CAMDEN TOWN HALL
LENDLEASE
PLANNING APPLICATION ADDENDUM
APRIL 2020
DESIGN & ACCESS STATEMENT
HERITAGE IMPACT ASSESSMENT

CAMDEN TOWN HALL - PLANNING APPLICATION ADDENDUM

This Design and Access Statement (DAS) and Heritage Impact Assessment (HIA) has been prepared by Purcell at the request of Lendlease on behalf of London Borough of Camden (W), the Client, as an addendum to the approved Planning Application 2019/2238/P and approved Listed Building Consent Application 2019/2257/L. The Statement describes the proposed amendments to the approved scheme that have arisen as a result of investigative survey information and client requests during RIBA Stage 4.

Proposed Judd Street Entrance - visual showing rebuilt stairs with contrast nosing and new glazed entrance lobby

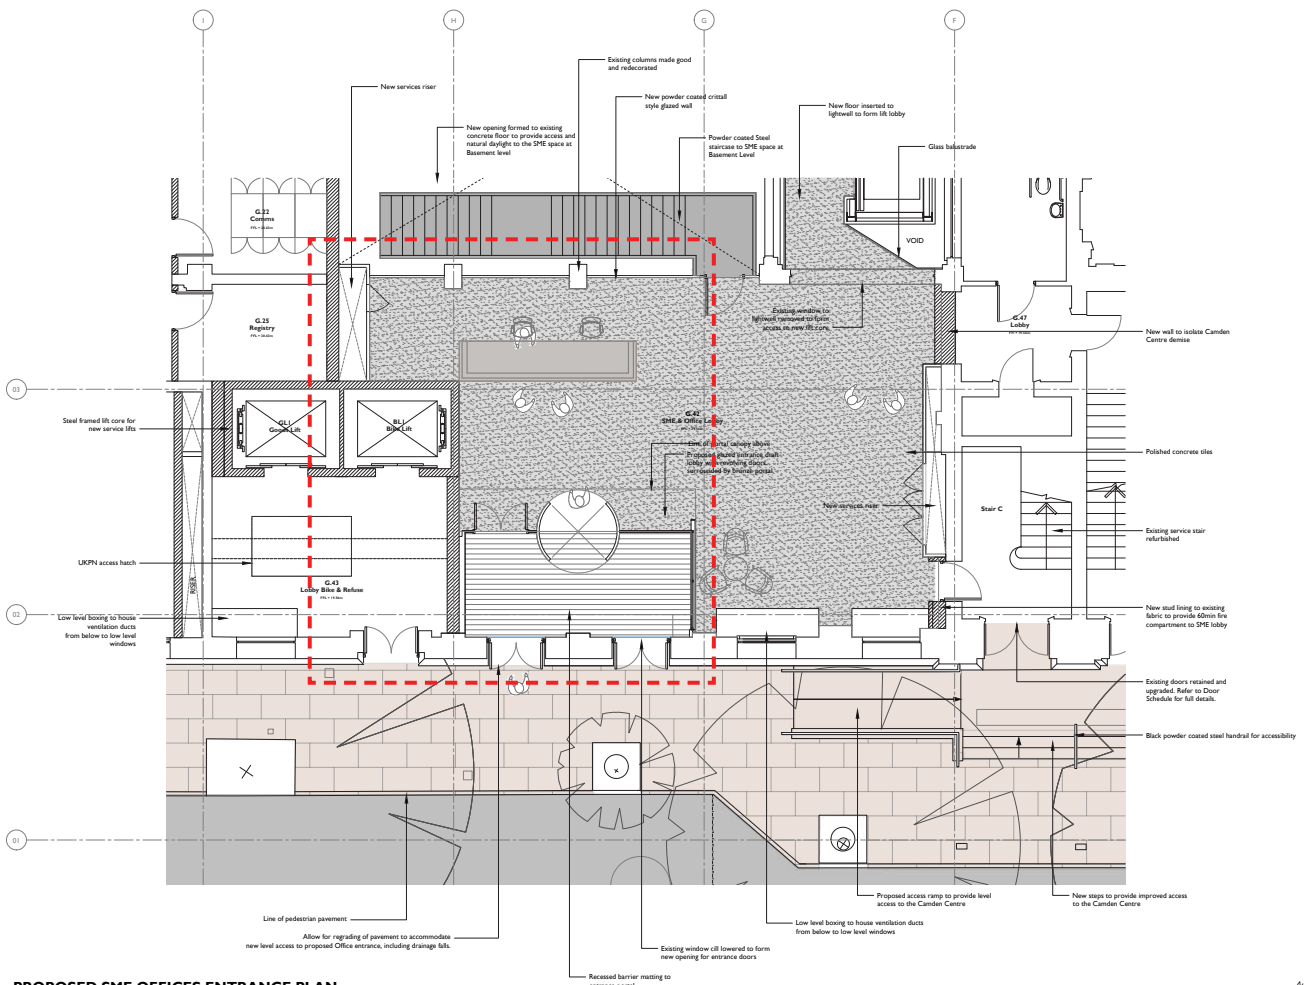
- 01 Stairs rebuilt following condition survey. Anti-Slip Nosings to be incorporated into new stairs to improve accessibility, durability and health and safety
- 02 New aluminium framed glazed draught lobby fixed back to stone walls in more sensitive locations than existing lobby to maintain internal thermal comfort levels for staff and visitors.
- 03 Automatic sliding doors

This amendment, therefore, calls for the removal and like for like replacement of the entrance steps with a new natural Yorkstone. Although every effort would be made to sensitively repair the existing steps, patch repairs may highlight the prior poor condition and be susceptible to further failure. To improve the visual distinction for accessibility, health and safety as well as durability of the new steps; an anti-slip inset nosing has been proposed to match the adjacent Town Hall Annexe redevelopment.

The approved proposal for managing heat loss and thermal comfort was to install heat curtains above each entrance door internally. Following further review with management staff, the Client has requested a more preventative measure of reducing heat loss into the entrance lobby and reception. With such high pedestrian traffic passing through the lobby and a requirement for doors to be propped open along the processional route to the wedding suites, there is a great risk of thermal fluctuation affecting the comfort levels throughout the ground floor of the Town Hall. This amendment, therefore, looks to reintroduce a draft lobby within the existing

entrance portico but executed with a much more sensitive design and fixings back to the stone portico.

The approved ramped entrance previously showed the existing door to the top landing to be removed to assist with wheelchair access. The proposal reinstates a new door within the existing opening to maintain a security line, and protect the historic image of the principal entrance facade.

Proposed Bidborough Street Entrance - Plan

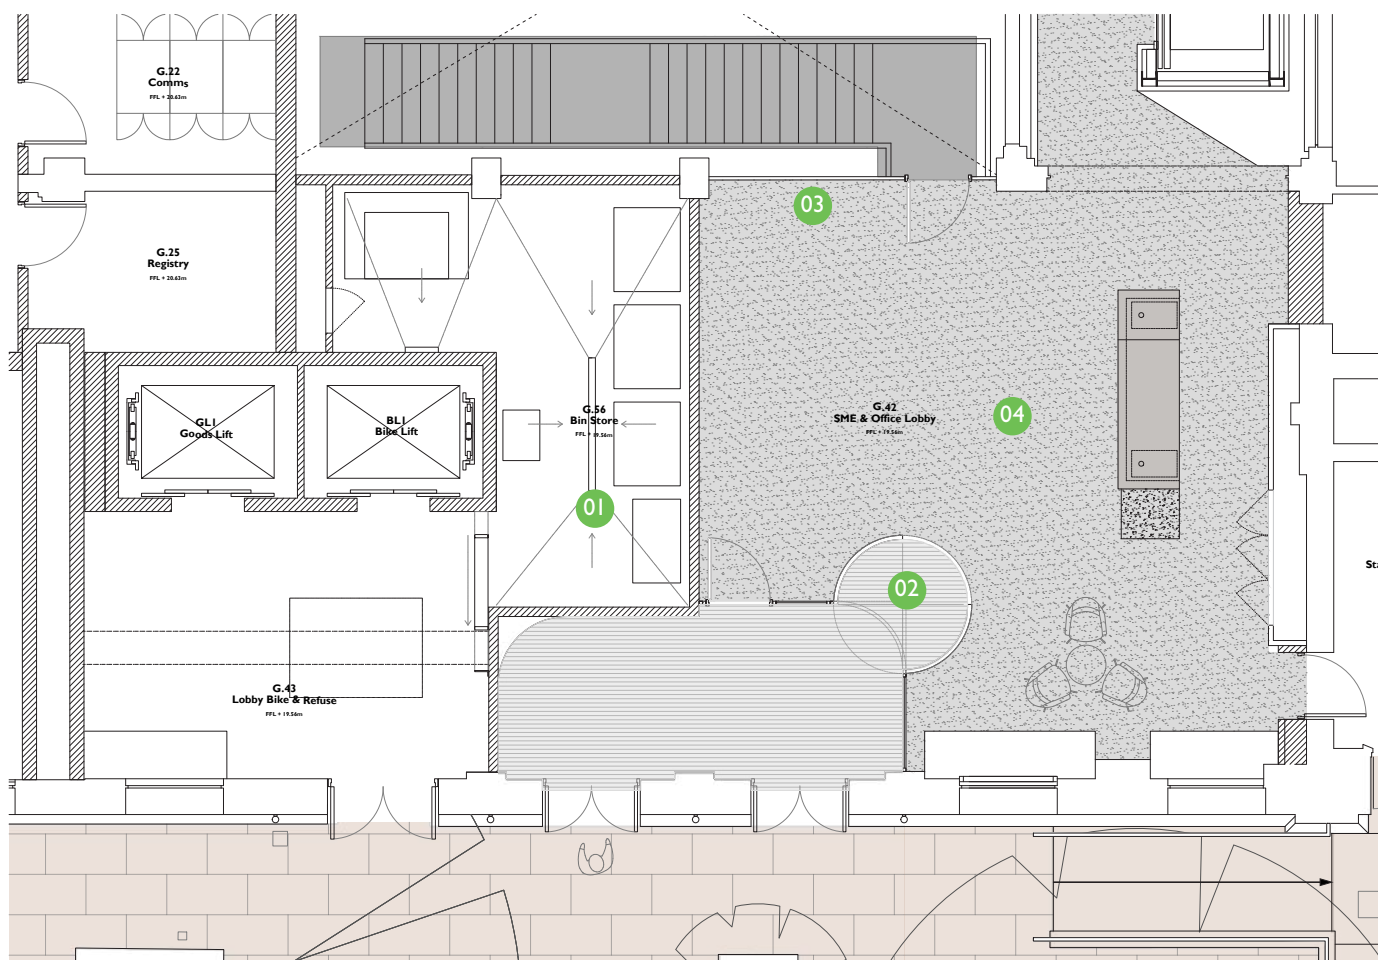
In the approved scheme the Bin Store was located at basement level, however, following a further review with the Client and Waste Management Consultants, it was requested that the bin store be relocated to Ground Floor Level, accessed via the bike and refuse lobby. The relocation mitigates the maximum 10 metre 'pull distance' of bins, requested by Camden's Waste Contractor. The waste maintenance strategy remains the same with only the location of the Bin Store updated

This amendment therefore shows the relocation of Bin Store to Ground Floor Level. In turn, this reduces the size of the Office / SME lobby and the extent of the glazed screen to the SME spaces at basement level.

There have subsequently been minor spatial alterations at basement level where the Bin Store was previously located – introducing a Prayer Room and Facilities & Maintenance Store.

- 01 Relocated Bin Store allowing easier access from refuse lobby at ground floor
- 02 Redesigned glazed lobby and revolving door placement
- 03 Reduced glazed screen to basement SME as a result of new Bin Store location
- 04 Reduced SME & Offices lobby area

Approved Visual - View from Bidborough Street Entrance towards new SME circulation

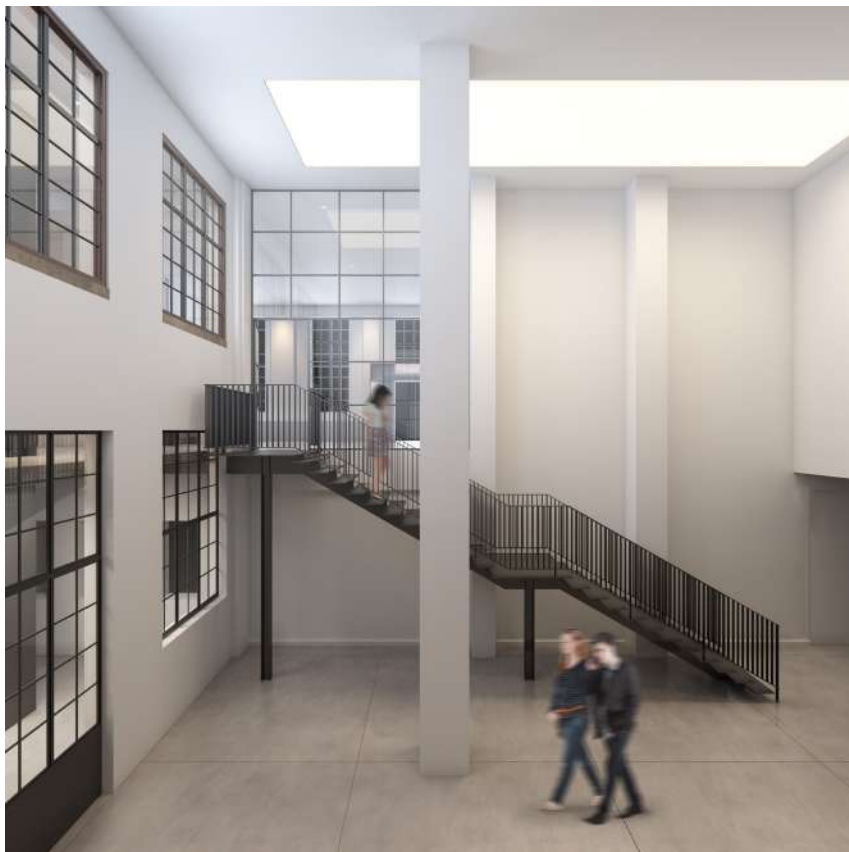
Proposed Visual - View from Bidborough Street Entrance towards new SME circulation

Proposed Visual - View from SME basement looking towards new SME stairs and Entrance Lobby

1940's Extension - Approved Works showing Demolition

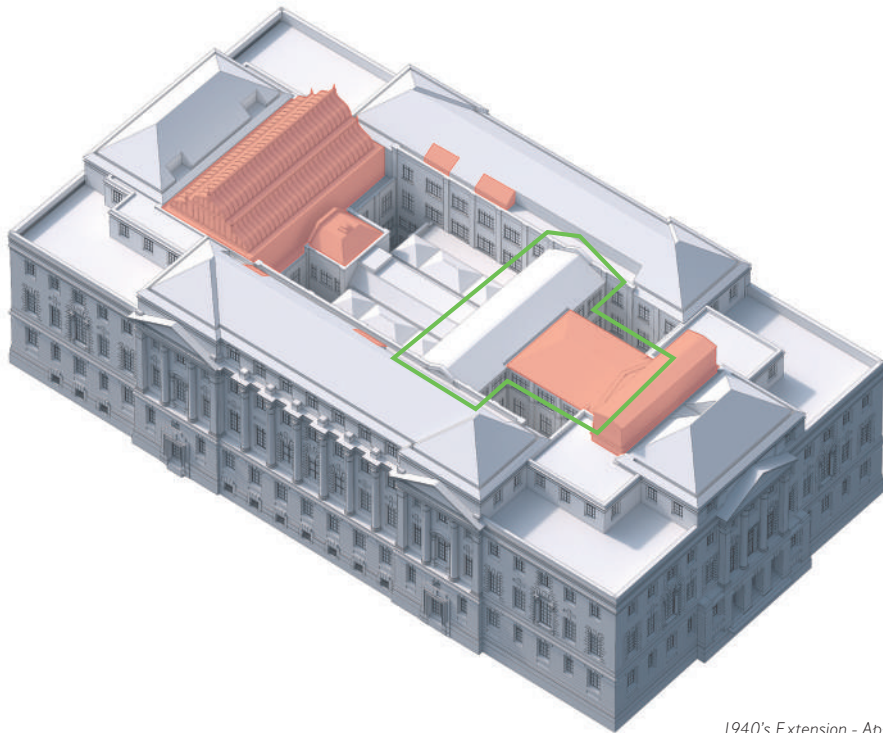
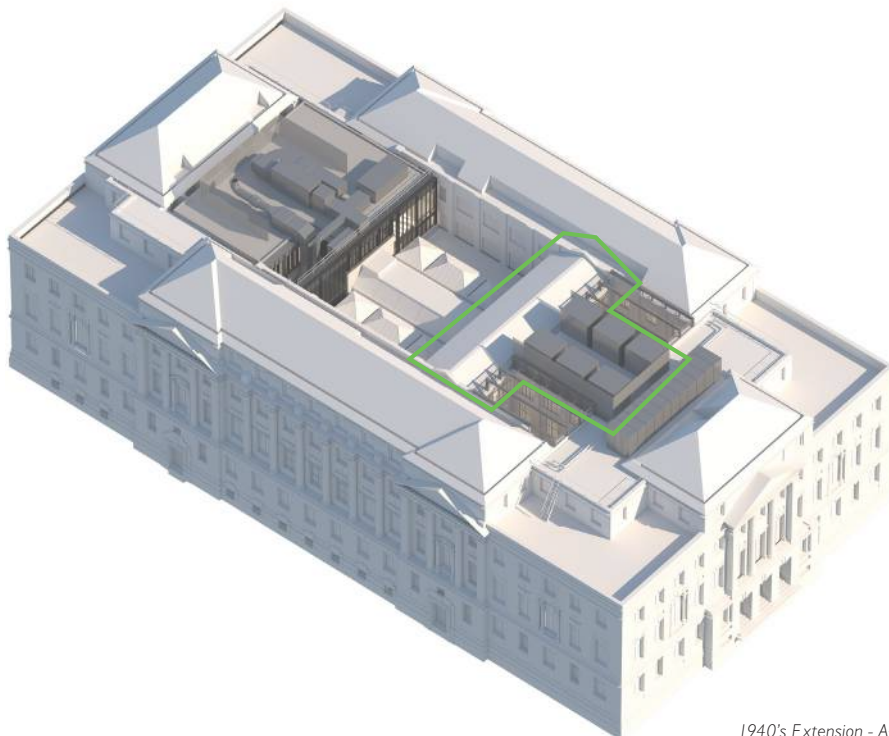
In the approved scheme, an area of pitched roof to the 1940s T-shape extension was proposed to be removed and replaced with a flat lightweight slab roof to house the ASHPs.

Initially, proposals looked to support the new roof slab directly onto existing columns at the Third Floor and carry the load to foundations through the existing columns at the lower levels.

Elevation showing the columns to be strengthened at GF level

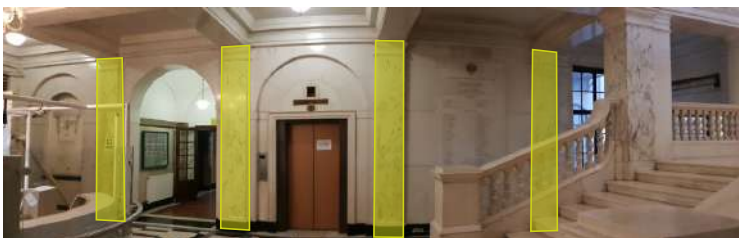
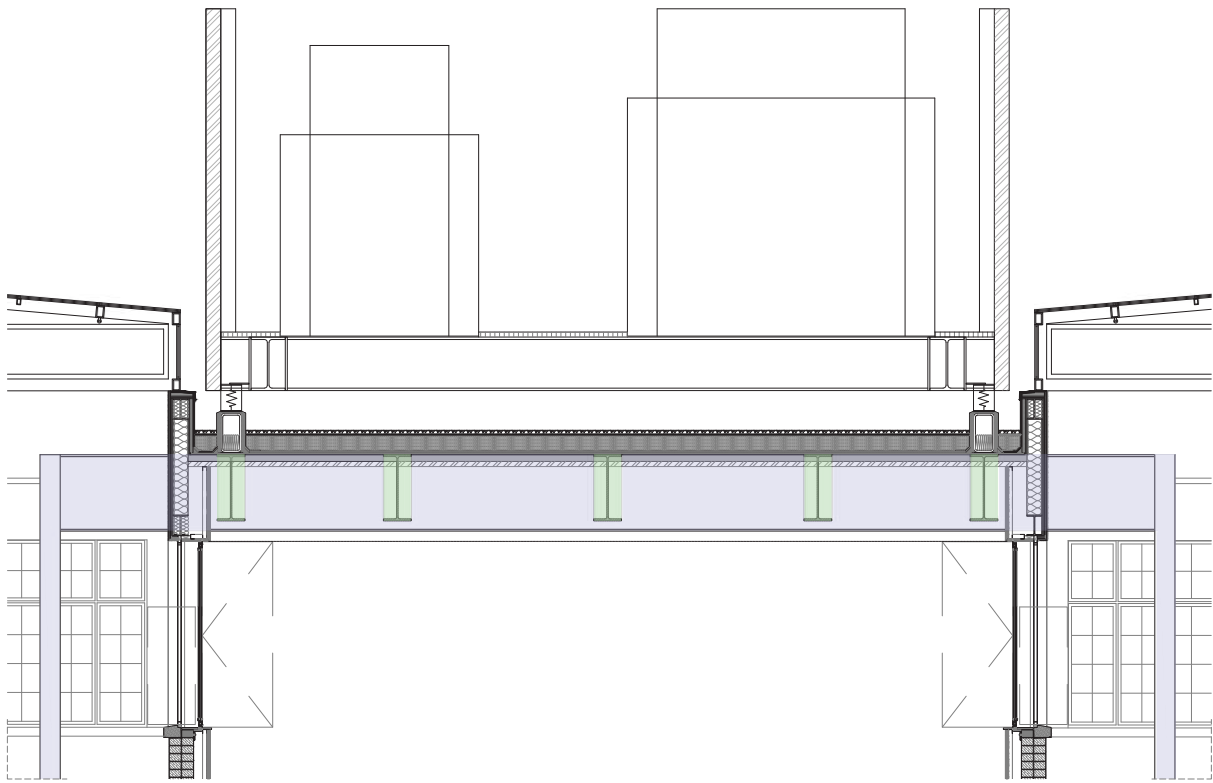
The surveys revealed that, where it had previously been assumed that the steel column structure ran from Basement to Third Floor Roof Level, in fact the steel structure terminates at 2nd Floor and the existing pitched roof was only supported on non-structurally sound brick piers.

Furthermore, due to the discovered condition/ capacity of the existing steel columns running from Basement to Second Floor, and the significant increase of the new load compared to the existing loading condition, it was identified columns would require extensive strengthening works.

These strengthening works would involve full height breaking of the existing historic fabric to expose the columns and carry out the strengthening works with additional steel elements. These works would be required at each level and for all 10 columns located under the 1940s roof, including at Ground and First floor, where the existing fabric is of highest heritage significance.

1940s Extension Proposed Structure - Section

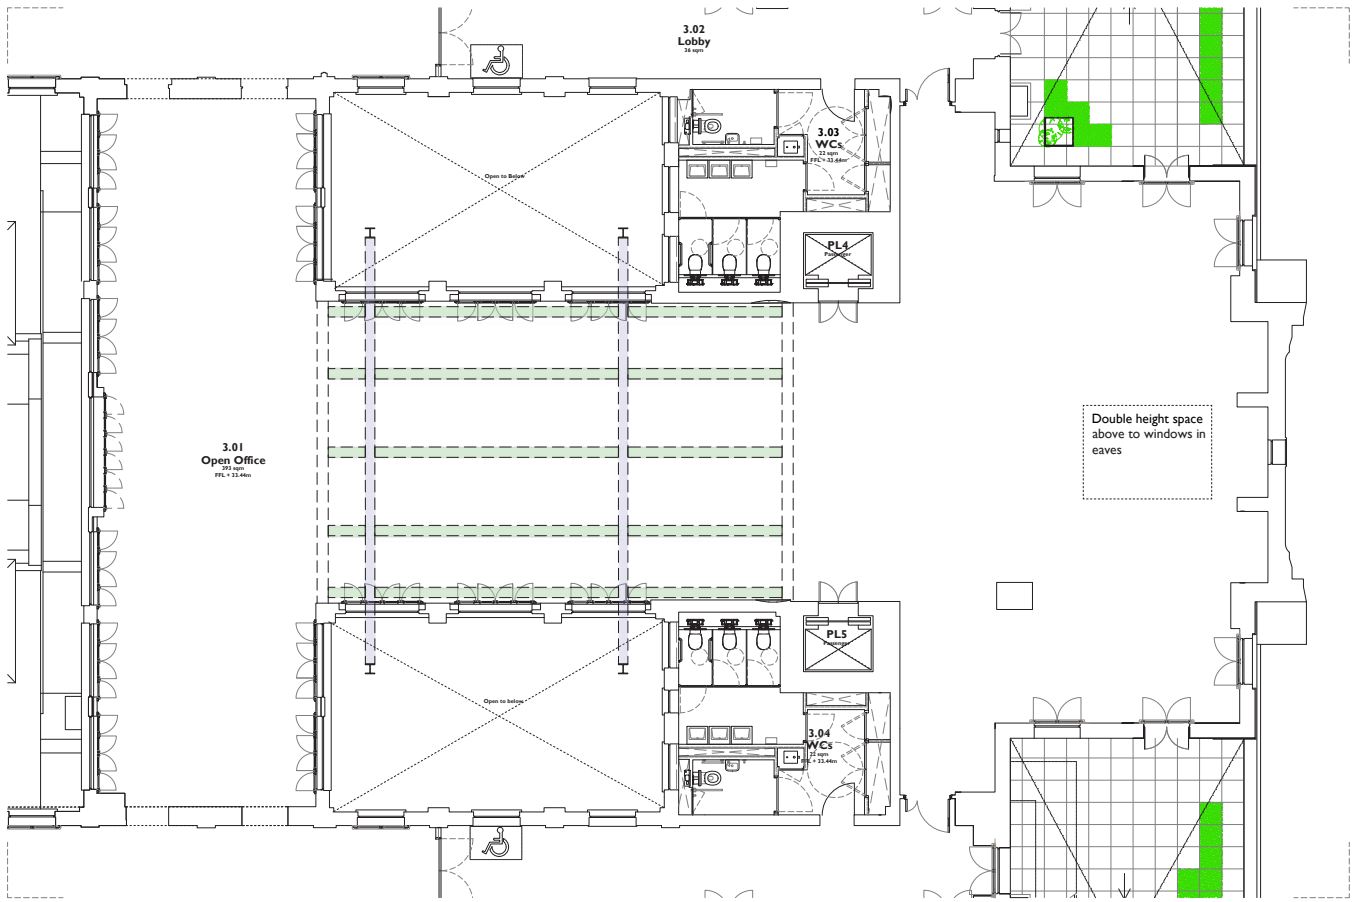
The amendment therefore provides an alternative, less intrusive solution that removes the need to strengthen the existing structure, and in turn, the need to break out any of the existing historic fabric. This solution utilises a new independent structural frame that aims to minimise the interface with the existing building fabric. This is achieved by introducing two new columns on each of the adjacent lightwells that will support the new flat roof slab. The new columns will be restrained laterally on every floor level and four new pad foundations will be formed at the basement level to support the load of the new structure and mechanical plant. With this solution, there is no need to rely on the capacity of the existing structure and consequently any potential strengthening works of the existing structural frame can be avoided.

Rooftop plant - Proposed 4th floor plan

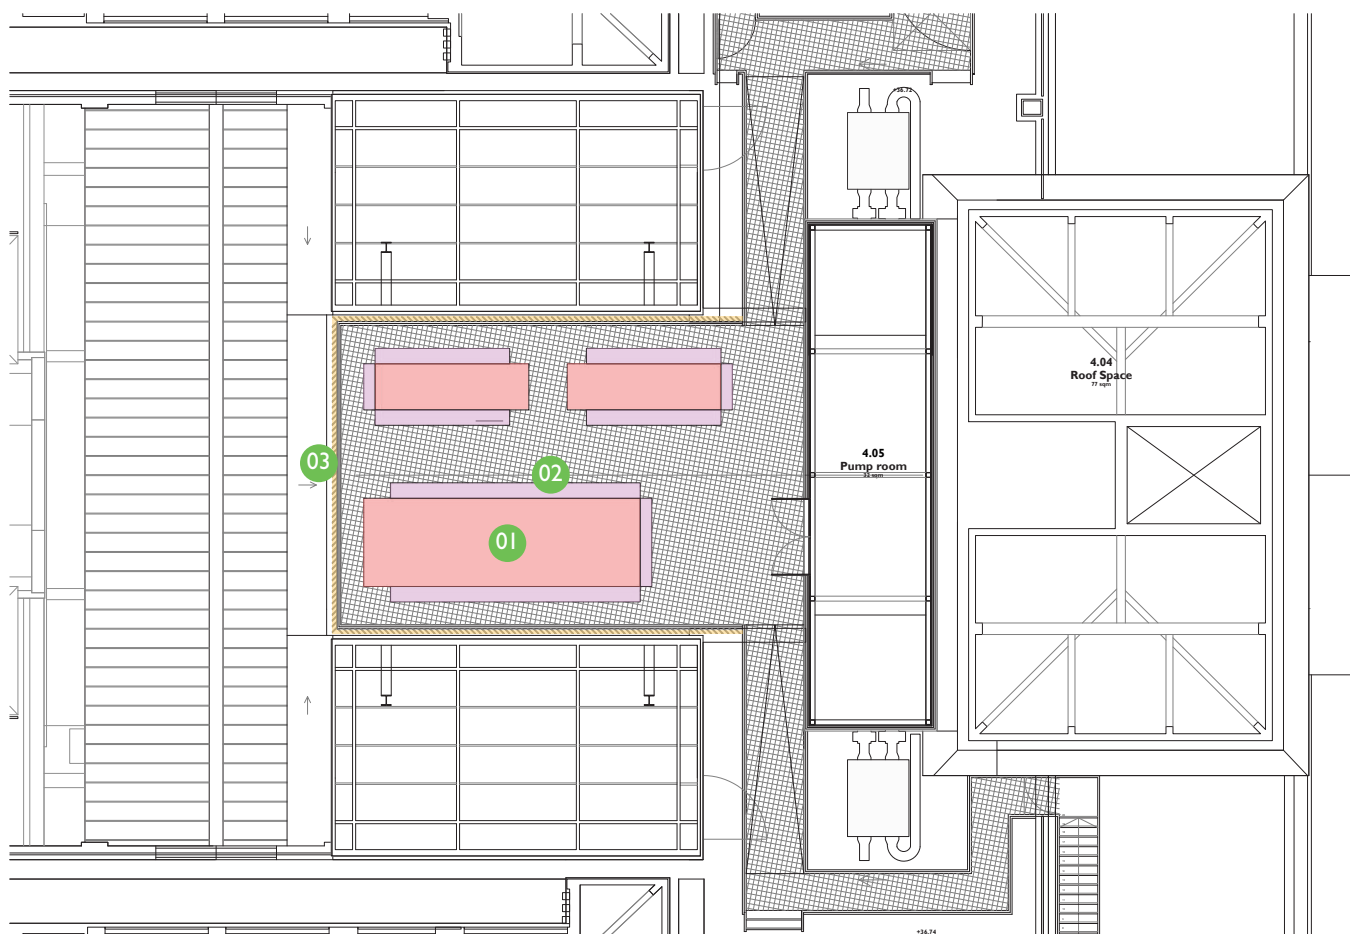
The Air source heat pump and attenuator arrangement has developed since the original designs. The arrangement has been re-sized to meet the requirements of the building loads and acoustics leading to an overall increase in the height of the arrangement.

Attenuators are mounted to the top and sides of the units to limit the noise outputs to within the agreed limits of the background noise. Additionally, ASHPs need to be mounted on springs and supported off a secondary structure to prevent sound transmittal via reverberation through the new lightweight structure.

A number of arrangements for the ASHPs have been explored with various manufactures and exploring various special arrangements on the roof. The most efficient option has been proposed with regards to meeting building loads whilst also balancing the overall height and meeting the acoustic attenuation requirements. This has resulted in 3 larger capacity ASHPs in substitution of 6 smaller capacity units in order to keep the overall height as low as feasibly possible.

- 01 ASHP unit
- 02 Acoustic attenuation
- 03 Acoustic louvred screening

Rooftop plant - Proposed section

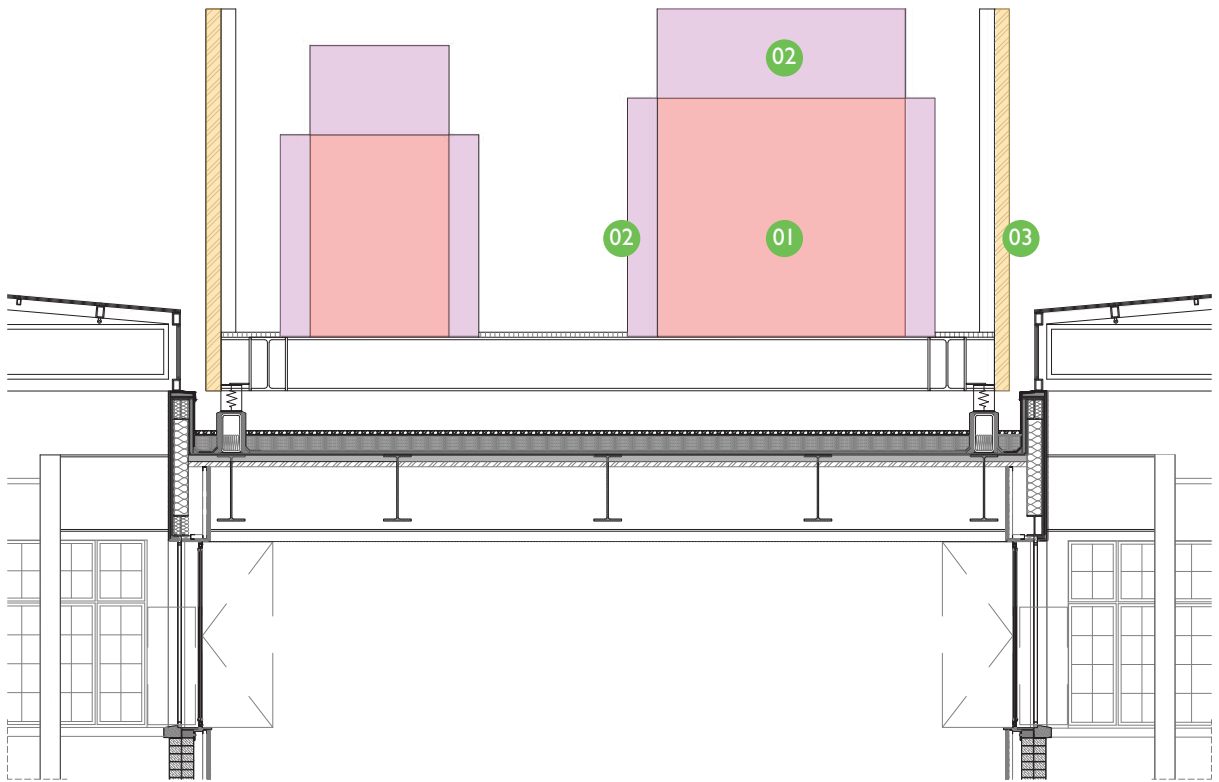
- 01 ASHP unit
- 02 Acoustic attenuation
- 03 Acoustic louvred screening
